# Access Compliance Report

## Public Rights-of-Way

Intersection ID: 52944	Main Street: CAMBRIDGE COMMONS DR	Cross Street: HARRISBURG RD	Location:	W
ADA ID: A2079706F515	Ramp Type: Para	Initial Pass/Fail: Fail	Overall Compliance: No	Severity Score: 25
Codes/Mitigation Info/Possible Solution		Field Measurements/Component Compliance

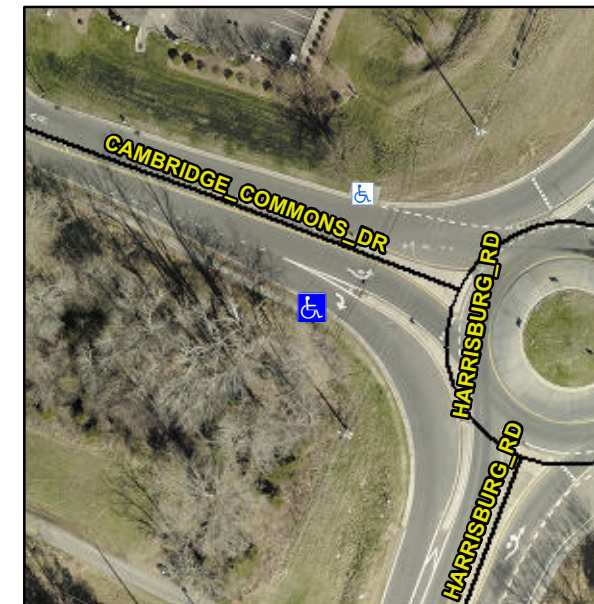
**RT RP < 5%, NO LT SW**

**R304.3.2**

**Remove & Replace Entire Ramp.**
